# **RAPPORTO DI NON CONFORMITA' A FORNITORE** **SUPPLIER NON CONFORMITY REPORT**

RNC Supplier	001/25	Date	14/01/2025

Picture 1: Microstructure found with the analysis in our metallographic laboratory.

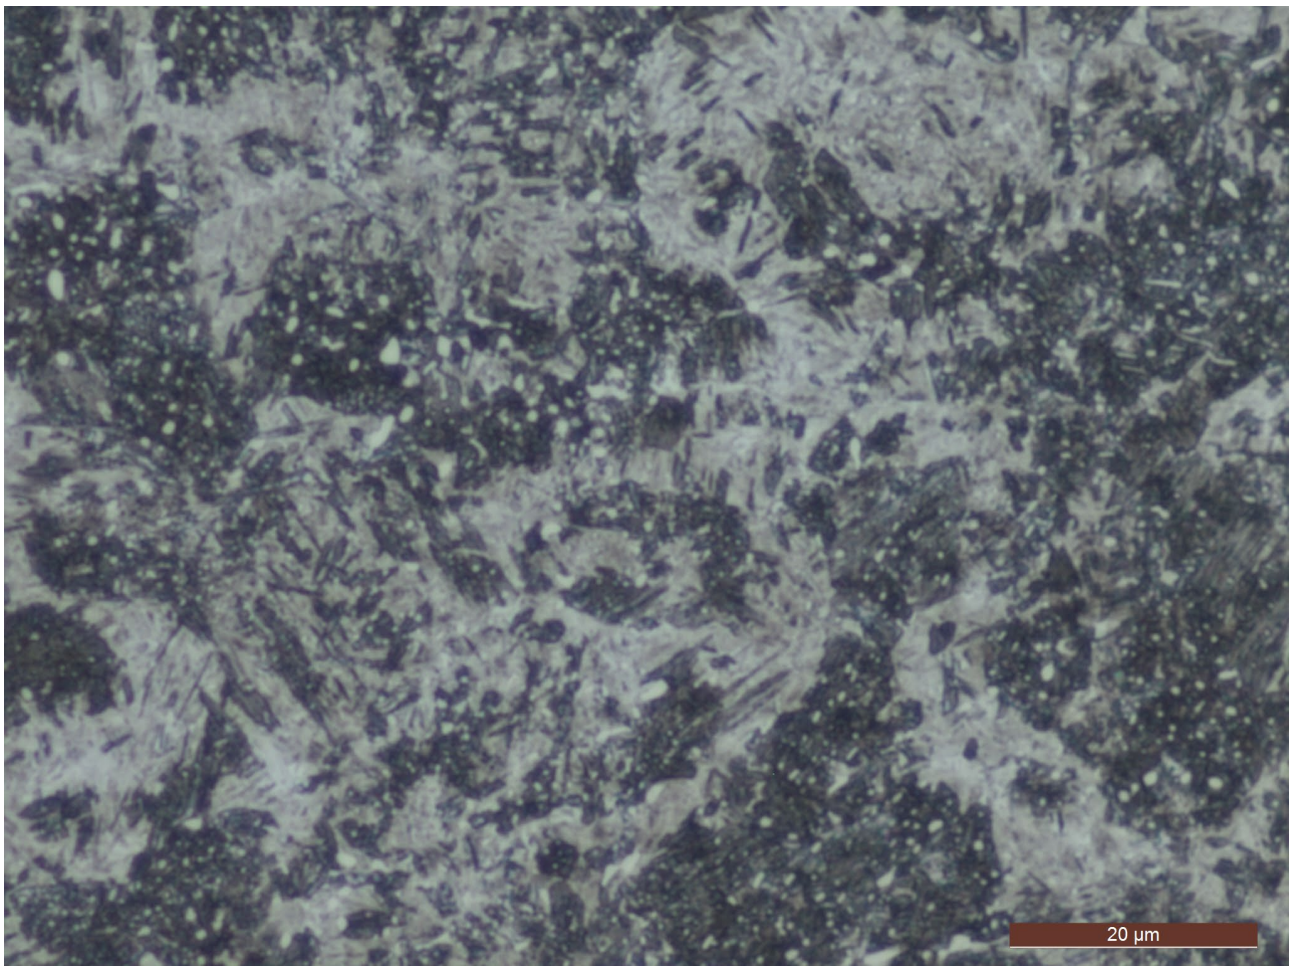
The cause, from our analysis, results that is the incorrect heat treatment execution. In the metallographic laboratory, we found, by analyzing a roller with low hardness, the presence of untransformed structures (dark spots with carbide concentrations, see attached picture).

The microstructure in these dark spots consists of Bainite and very fine Pearlite. This structure indicates insufficient temperature or time during austenitization phase before quenching.
